TELETEXT COLOUR BOARD. Construction and Modifications.

TELETEXT COLOUR GRAPHICS BOARD PAGE 1 of 8

Divider Sub-board Components.

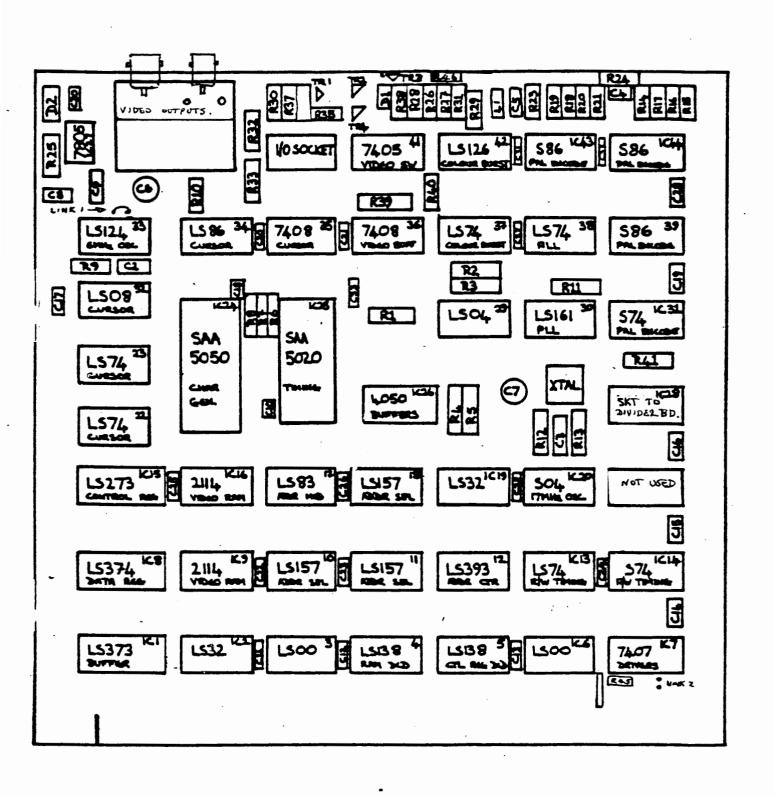
The new divider board takes the 17.734475 from header plug (pin 2) which occupies the socket of the no longer used IC28. Output of the divider board returns to the header plug (pin 5). The board itself should be mounted piggy-back on to the colour board so as to keep its connection leads as short as possible.

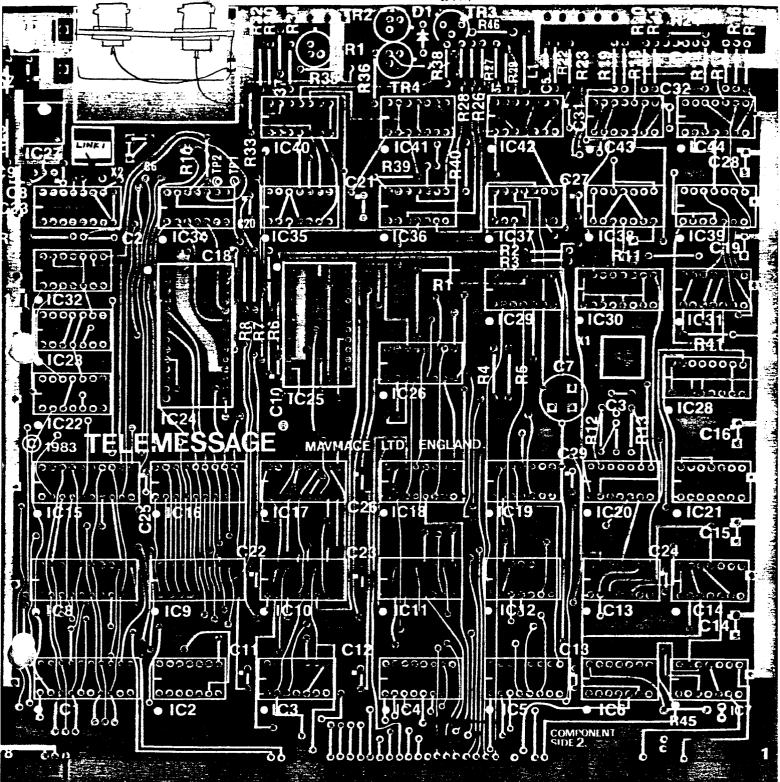
OMIT MODULATOR AND REPLACE IT WITH BRACKET HOLDING BAC SOCKETS.

REPLACE R46 WITH LINK 3

1630 CUT FRACK GOING TO PIN 3 (ONLY)
1630 CONNECT PIN 3 TO OY.
1628 CUT TRACK GOING TO PINS (ONLY)
1628 CONNECT PIN 5 TO 1621 PIN 12

LINK Z IS BELOW ICT OMIT THE LINK AND ALSO OMIT R45
